Report of the Chief Planning Officer

CITY PLANS PANEL

Subject: Position Statement: 17/03974/RM Reserved Matters application for 292 dwellings including layout, scale, appearance, landscape and access. Northern development pots on land south of railway line at Thorpe Park, Leeds, LS15 8ZB

CITY PLANS PANEL

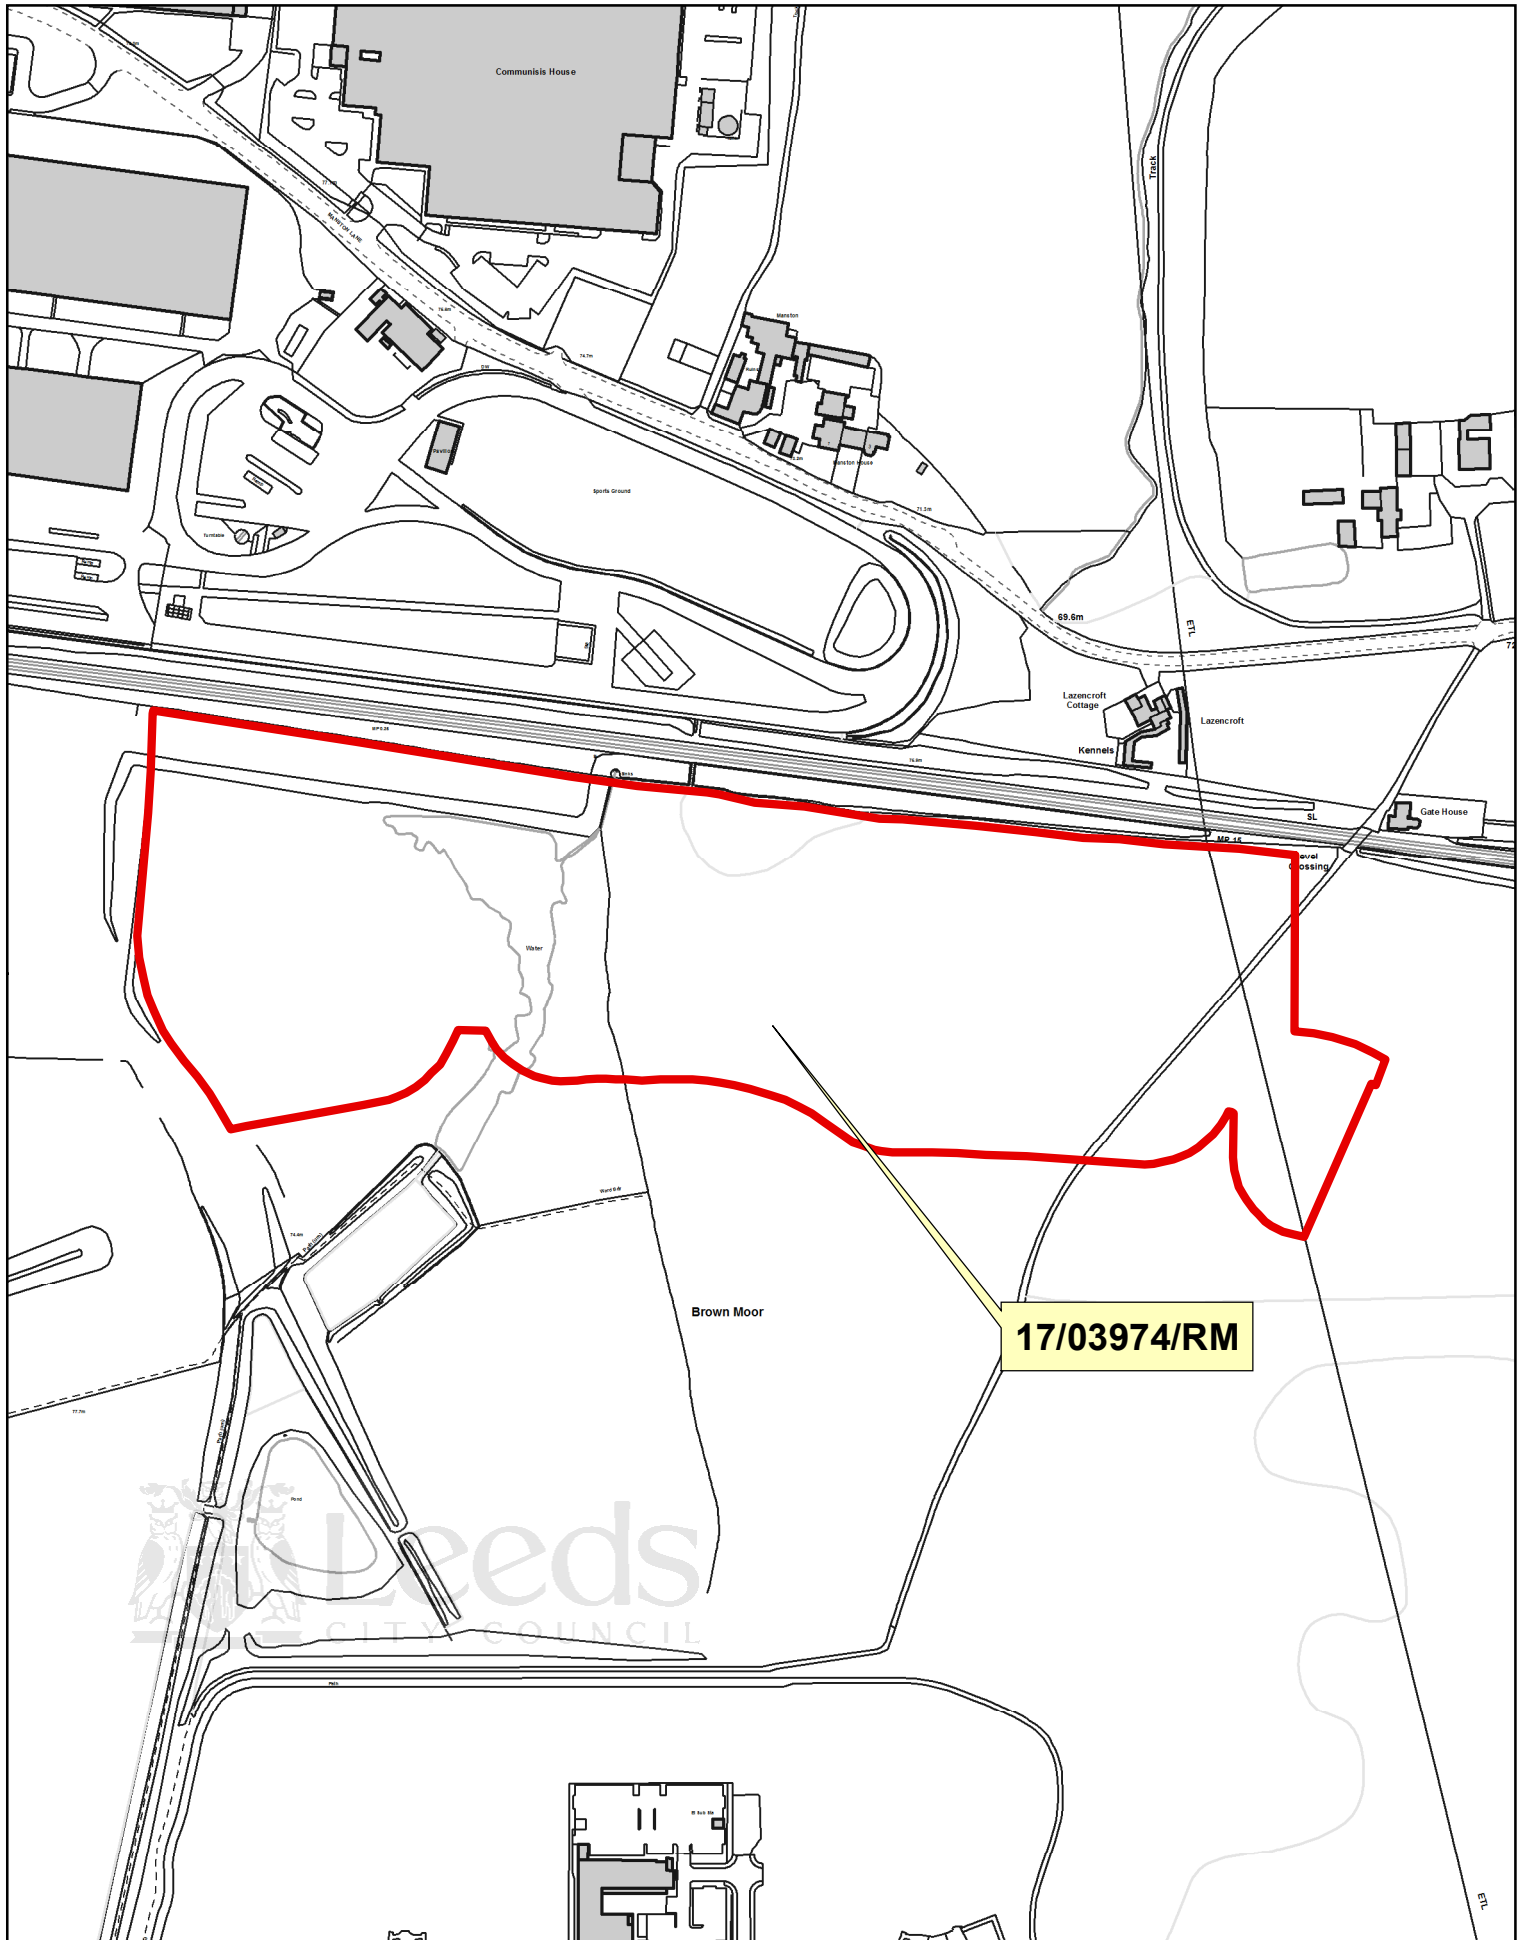
- We do not object on design grounds but have a number of comments:
 - I) The division of the site into groups of “modern” style houses and retro “garden village” style houses seems arbitrary.

- II) The flats seem bulky and boxy in contrast with the houses.
 - III) The energy plan suggests that the means of meeting Condition 35 of the outline will be solar photo-voltaic panels on south facing roofs however none are shown on the drawings; these should be integrated into the roofs using photo-voltaic tiles rather than added on as panels.

- Members made reference to the outline Design Code Addendum for the site, earlier Member consultation on the proposals, and the expectation for a contemporary design of house types.
- The design of the proposed house types was not inspiring.
- This was a unique location, and traditional house types was unacceptable in this context, and “incredibly disappointing”, members wish to see a contemporary, highly sustainable design to complement the design features of the wider Thorpe Park development.
- Members queried if there were any ongoing discussions about transport links.
- The easternmost green finger was weak and needed to be enhanced to connect into the site and the adjacent park in line with the approved masterplan.
- There were concerns about the small size and northern orientation of the gardens to the railway line.

- It was noted that little additional detail was provided of landscaping and that green infrastructure and greenspace provision required improved “green finger” connectivity between the different phases and also to Central Park, in respect of the easternmost ‘green finger’

Question 1: Are members content with approach of having two character areas and the more contemporary design now proposed?

Question 2: Are members content with the active frontages with central park?

Question 3: Are members content with the overall masterplan in relation to the green infrastructure, and specifically the easternmost green finger?

[Flats over garages are being removed from the scheme]

[This concern has been reiterated by officers, the layout plan is being amended, and this will be reported at the meeting]

10.5 In responding positively to these comments Redrow have sought to introduce a more contemporary design of dwelling facing central park and the main Thorpe Park developments. Two broad character areas are now proposed. That which faces central park and running up the ‘green fingers’ which project into the development now makes use of a more contemporary design, using brick, light render and timber cladding with grey windows, similar to the style of dwellings which members saw at Derwenthorpe. Design colleagues comment that they are more contemporary in appearance and are considered to be based on simplicity, having a balanced order in terms of window to wall ratios and window proportions, making use of a simple palette of materials in a disciplined manner. Some of the palette of materials continues into the second character area bringing overall cohesion and consistency to the development as a whole.

10.6 In responding to Members’ concerns Redrow have also agreed to remove the flats over garage units (6 No.) to ensure a continuous active frontage with the park. Whilst officers had expressed some concerns about the easternmost ‘green finger’ as initially shown, Redrow have now revised this detail in view of the concern of Members expressed earlier, and it is now in more in line with the approved masterplan.
